Subject: USNRC Docket No. 72-1014, TAC L23344
HI-STORM 100 Certificate of Compliance 1014

We have reviewed the preliminary Certificate of Compliance (CoC) and Safety Evaluation Report (SER) for our HI-STORM 100 System amendment request that was enclosed with the above-referenced letter. The two tables attached to this letter contain our comments on the CoC and SER. Table 1 contains comments on the CoC and its appendices. Table 2 contains comments on the SER.

Table 1
Holtec Comments on Preliminary CoC

Table 2
Holtec Comments on Preliminary SER

Figure 2.A.1;
 Typical HI-STORM/ISFSI pad Fastening Detail

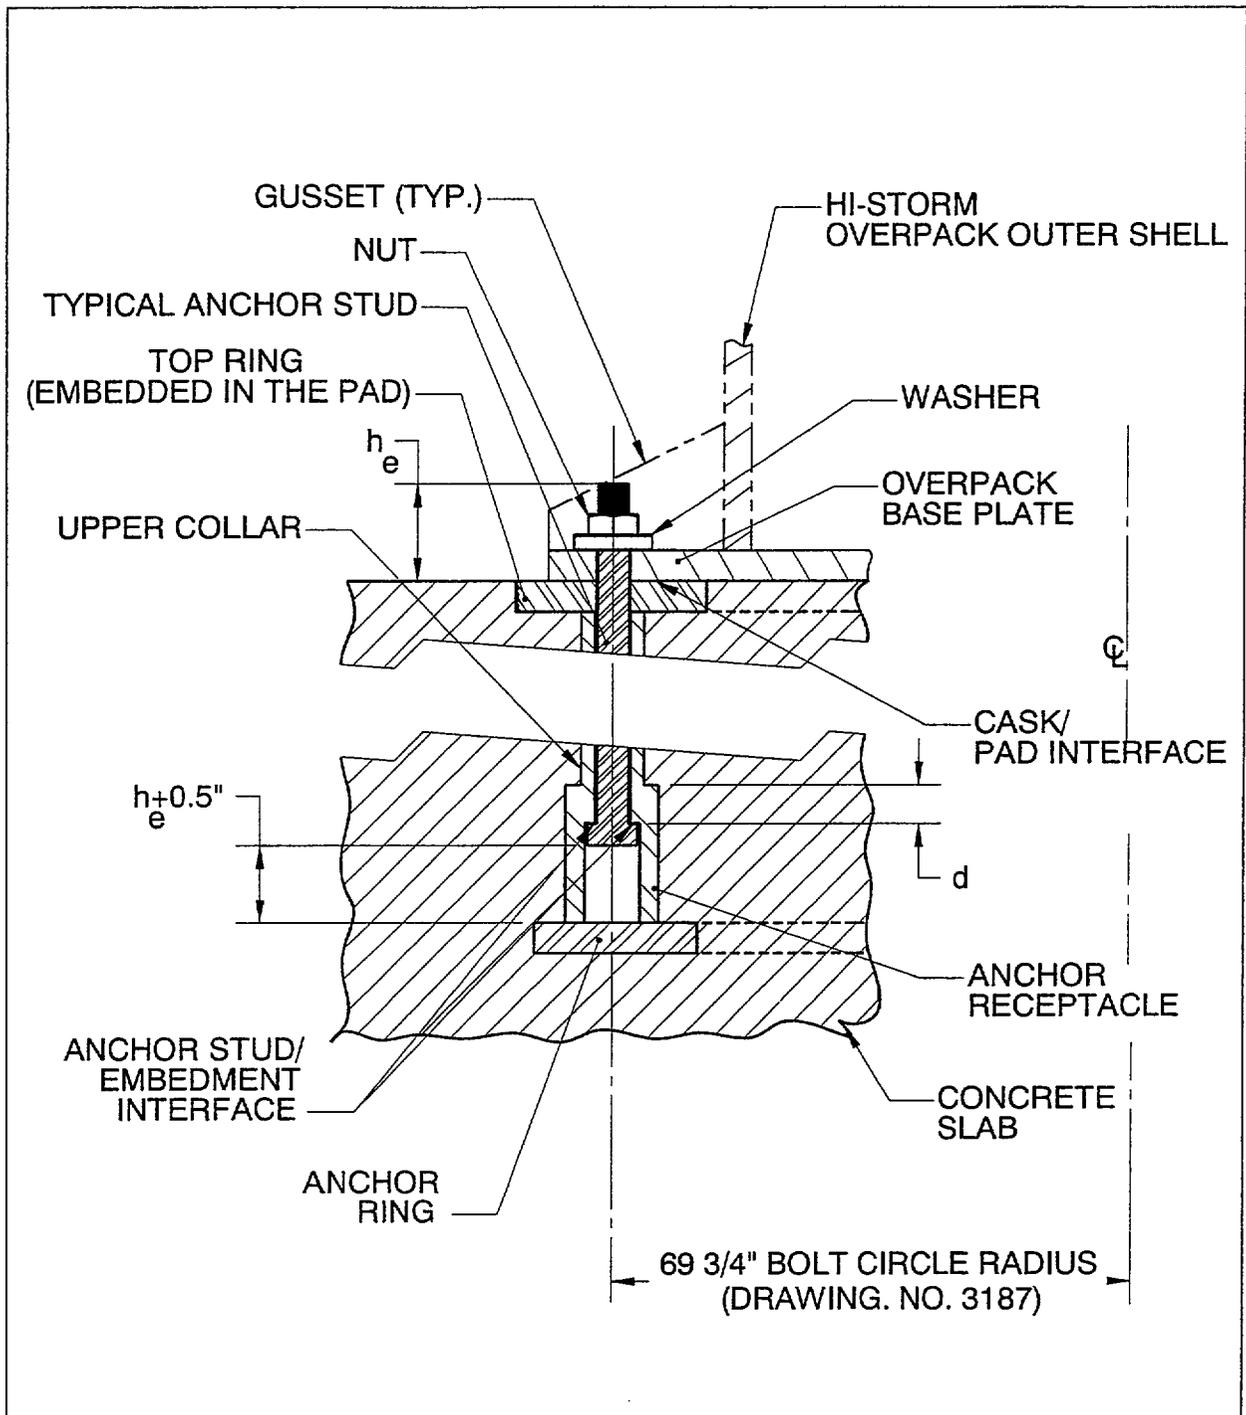
To address the comment in the last sentence of SER Section 2.1, we enclose a proposed modification to FSAR Appendix 2.A, Section 2.A.3 to better describe those components of the cask anchorage system that are important to safety. Assuming these changes address this SER comment adequately, they will be included in Revision 1 of the FSAR.

NEW → iv. The load-bearing members of the HI-STORM 100A anchorage system shall be

considered important-to-safety. This includes the following components shown in Figure 2.A.1: anchor stud and nut, top ring, upper collar, anchor receptacle, and anchor ring.
